Replacement of rotten floor joists at 511 16th Street, Unit 3A, Miami Beach FL 33139.

Building department comment:

An Interior Remodel for:
1600 Drexel LLC

Project Address:
511 16th street, Unit 3A,
Miami Beach, FL 33139

S-01

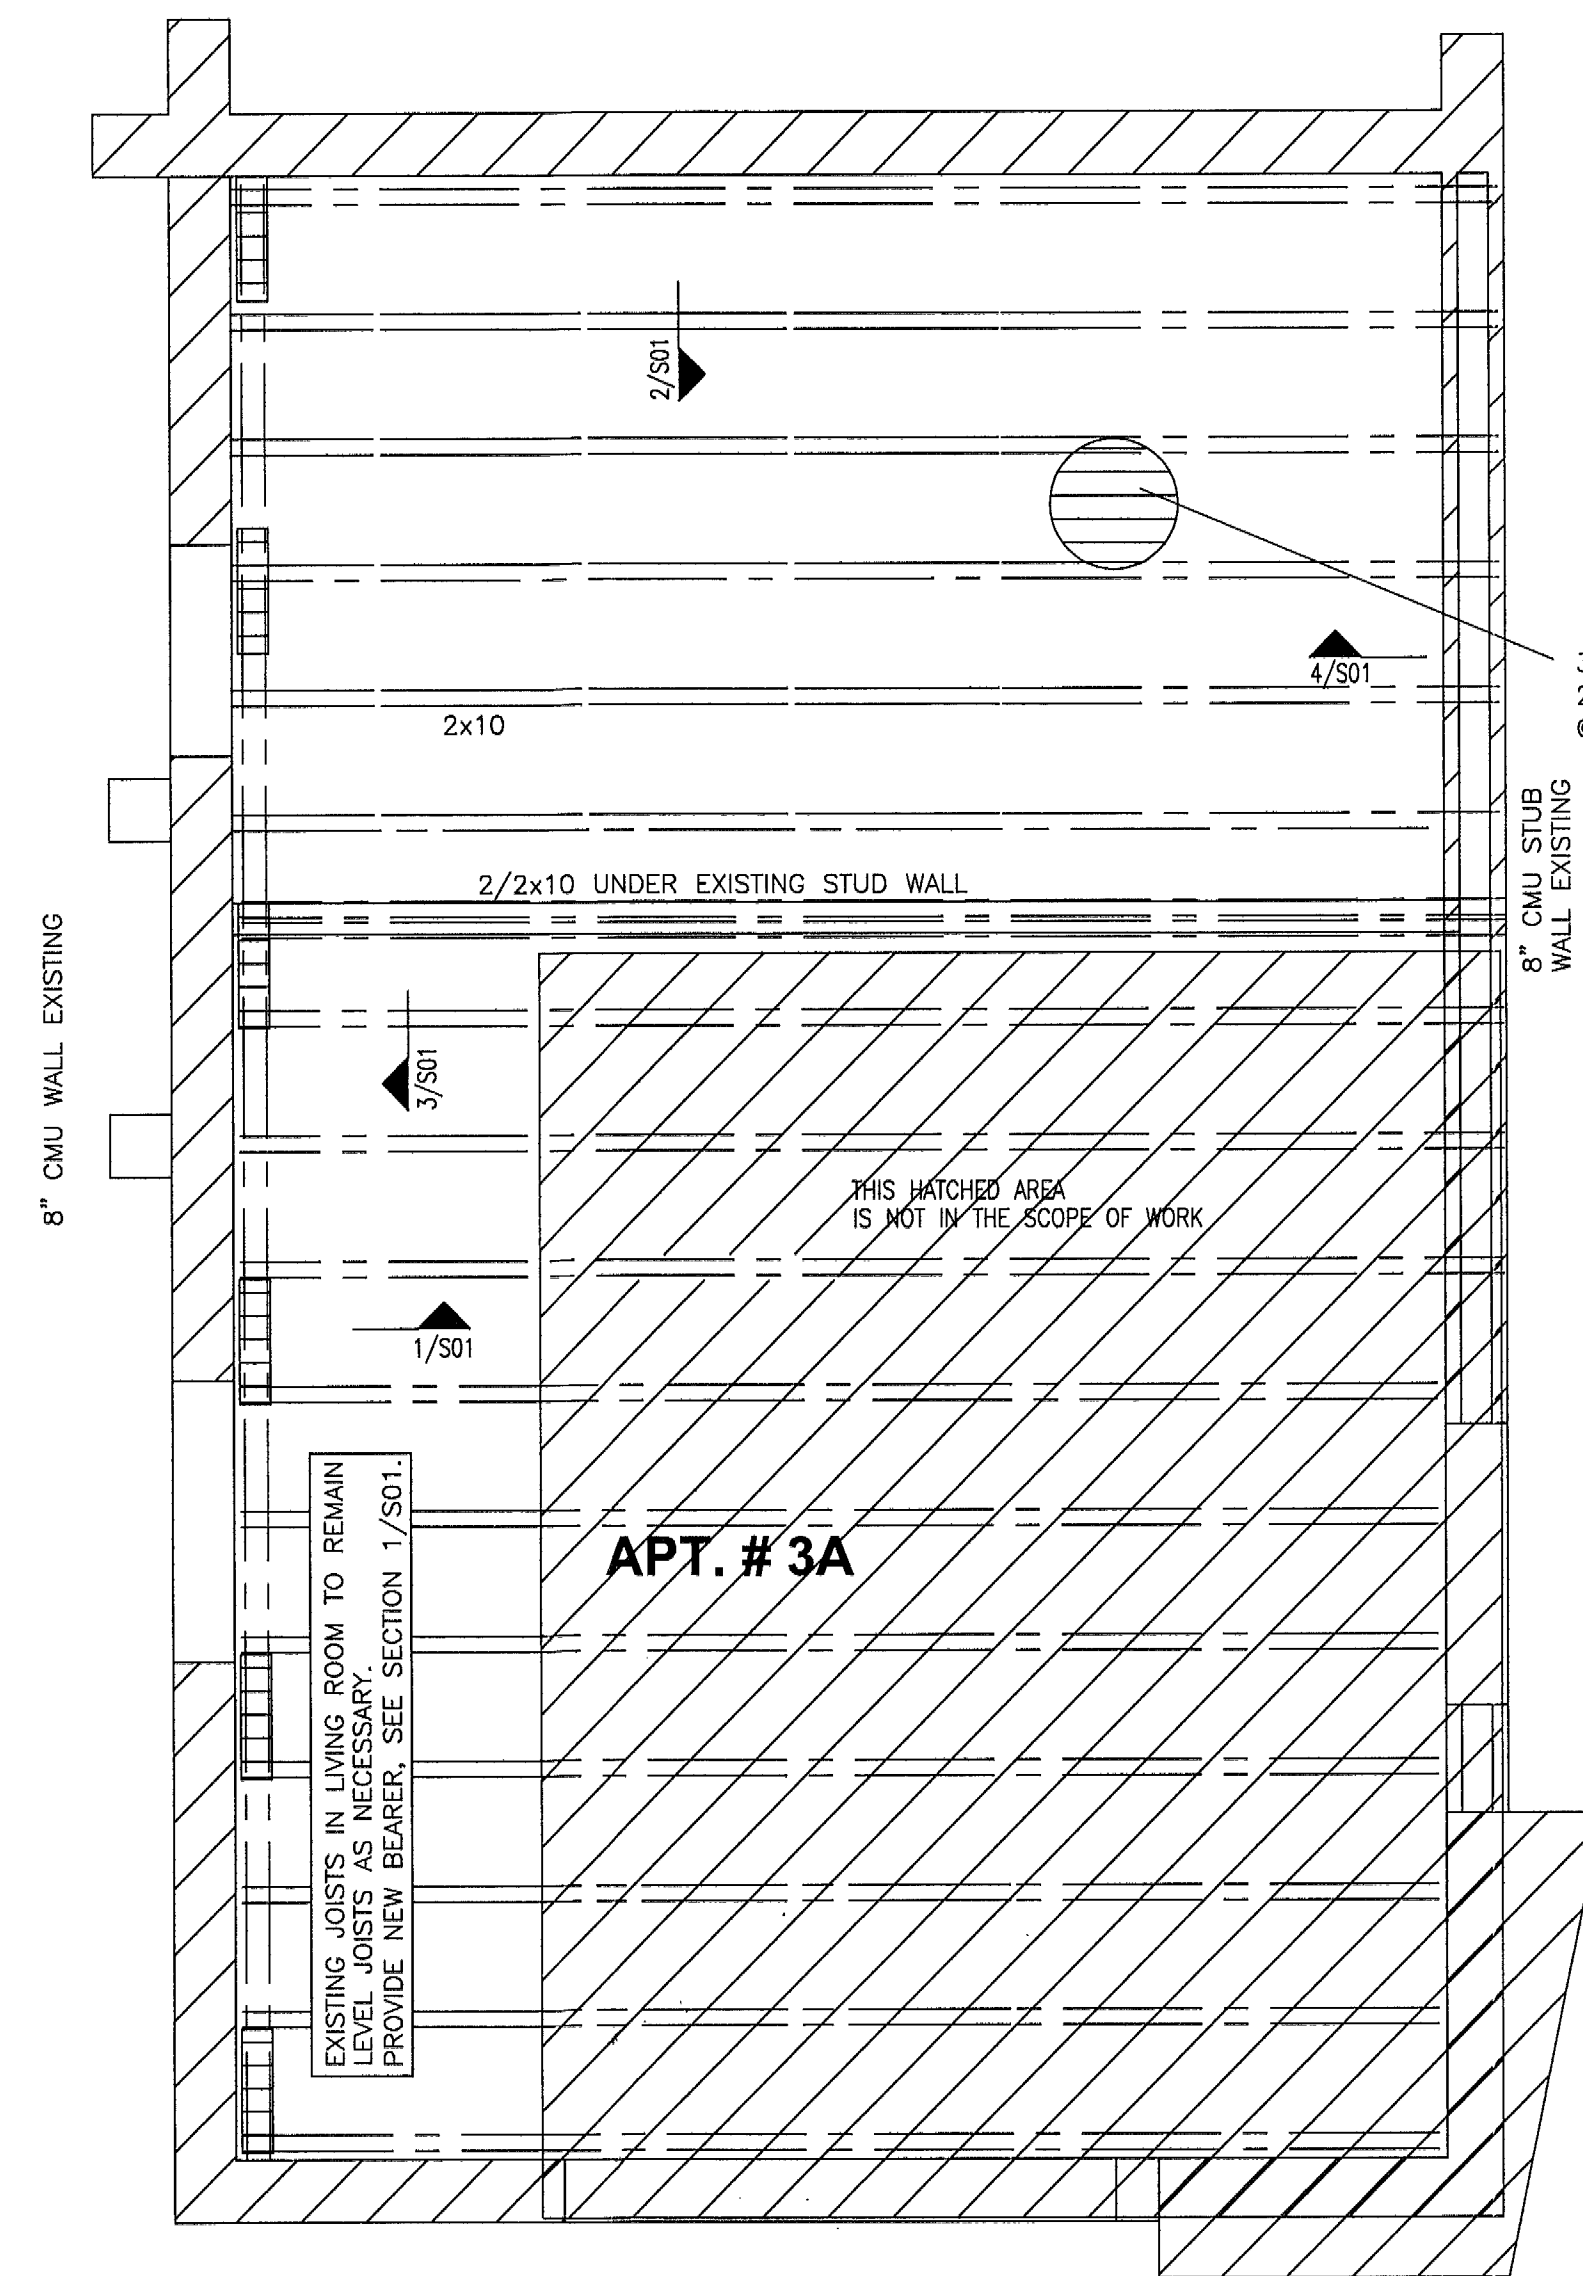
Provide a report or letter by a Registered Engineer or Architect after a preliminary inspection and describing existing conditions of the building and required repairs. 1.1 If the report determines that the repairs are nonstructural and do not exceed 25% of the replacement value of the building. Repairs may be made per FBC Exist. Bldg 506.2.4, 1.2. If the report determines that there is structural damage. The building must be evaluated as per FBC Exist. Bldg. Sec. 506.2.2.1 1.2A (Provide evaluation calculations) If the Pre-damaged building is found to be not in compliance. Provide repair details and calculation as required in Sec. 506.2.2.3 1.3 If the report determines that there is structural damage to the vertical load carrying components, (exposed or deteriorated reinforcing etc.) the repairs must comply with Section 506.2.2 or 506.2.3 1.4 If the report determines that there is structural damage to the lateral wind resisting system (exposed or deteriorated reinforcing etc.) the repairs must comply with Section 506.2.3.1 or 506.2.3 2 A Florida Licensed Professional Engineer or Registered Architect shall prepare plans and/or elevations indicating locations of observed damage or deterioration and describing extent of damage observed. 3. A Florida Licensed Professional Engineer or Registered Architect shall prepare a procedure and repair details required for various degrees of damage.

Rotten floor joists in area shown. See attached floor plan sheet and submitted S01.

The roof and bearing walls of the building shall not be repaired. The lateral load bearing system has not been damaged. The floor joists and floor deck are to be replaced as required because of the rotten joists.

1. -Replace partially rotten floor joists in bathroom area, see attached floor plan showing which floor joists require replacement.
2. -Replace damaged floor joist bearer along west exterior wall (in Living room and Bathroom). Provide new bearer per structural drawing S01. See attached sheet 9 of Southern Pine load tables for allowable span for 2x10.

3. -The floor joists in Living room shall remain (new bearer along west wall as noted above)
4. -Repair existing, partially damaged, concrete packing on stem wall under exterior door threshold in living room, where shown on attached floor plan. Replace stem wall packing with concrete block packing.
